SCS ENGINEERS, PC

Subject: Design Hydrogeologic Investigation and Report Revisions
Permit Application for A-1 Sandrock CDLF Phase 2A
Greensboro, North Carolina (Guilford County)
Facility Permit No. 4117-CDLF-2008

Documentation of Report Revisions based on regulatory review comments

Test Pit 13

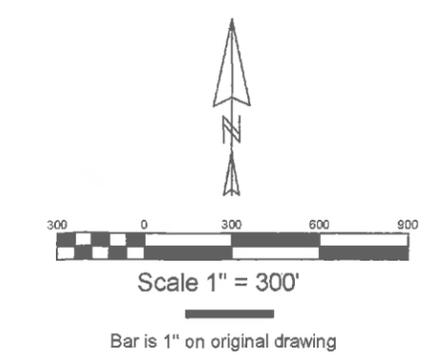
- 7 Addition of Test Pit Logs (four pages)
Page 12 substitution of correct photo for TP-13
- 8 Revision of Drawing M1 (small map) for Ground Water Monitoring Plan
- 9 Revision of Drawing M1 (small map) for Landfill Gas Monitoring Plan
